MIL-K-71151 (AR)
AMENDMENT 1
10 March 1995

MILITARY SPECIFICATION

KIT, REFURBISHMENT, FOR CARTRIDGE, 60MM
PRACTICE, SHORT RANGE, M766
LOADING, ASSEMBLING AND PACKING

This Amendment forms a part of MIL-K-71151 (AR), dated 1 November 1993, and is approved for use by the U.S. Army Armament Research, Development and Engineering Center, and is available for use by all Departments and Agencies of the Department of Defense.

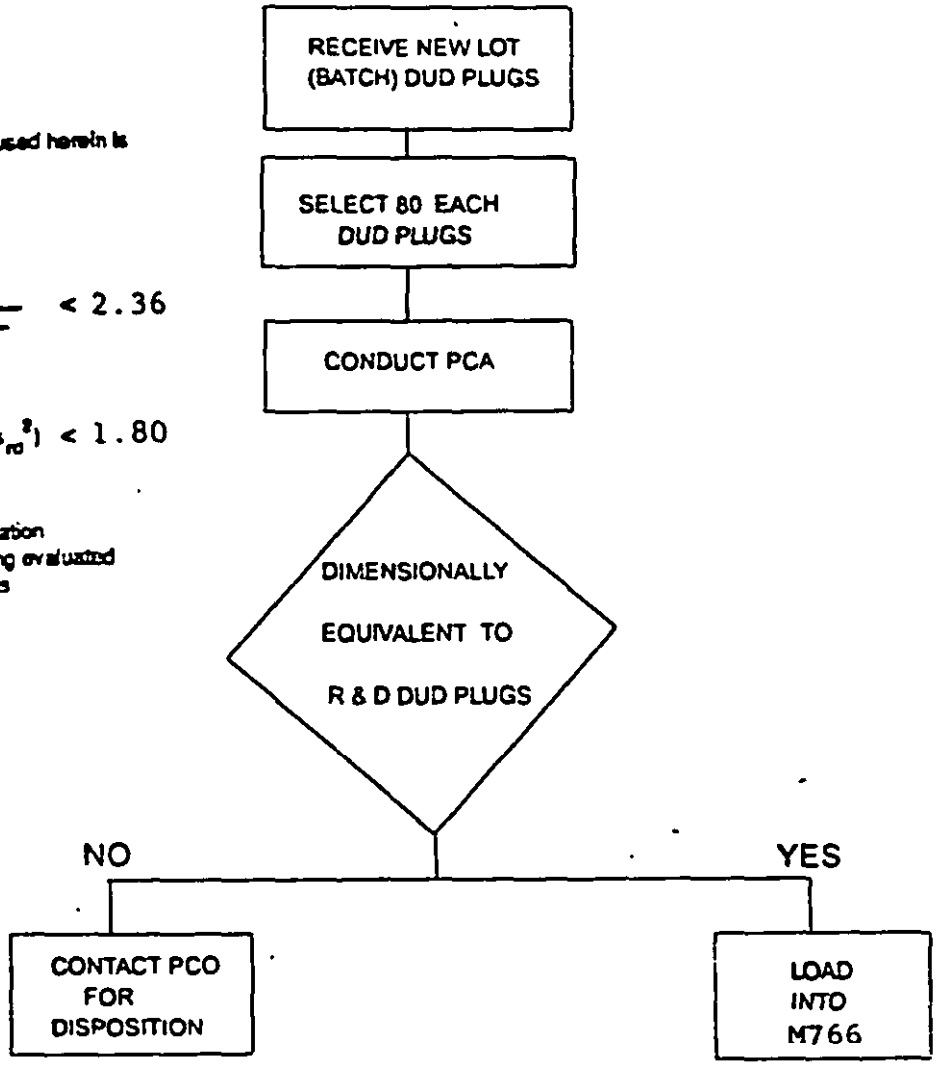
Add new paragraph 6.10 as follows:

"6.10 Dud plug usability criteria. The contractor shall provide dud plug material certification to the government for each inspection lot.

Each inspection lot of dud plugs shall be dimensionally inspected in accordance with the following chart.

The term "equivalent" as used herein is defined as follows:

Dimensional:

$$\frac{\left|\bar{X}_n - \bar{X}_{rd}\right|}{\sqrt{(s_n^2/80) + (s_{rd}^2/50)}} < 2.36$$

$$(s_n^2)/(s_{rd}^2) < 1.80$$

where: $\bar{X}$ = mean
s = standard deviation
n = dudplugs being evaluated
rd = R&D dudplugs
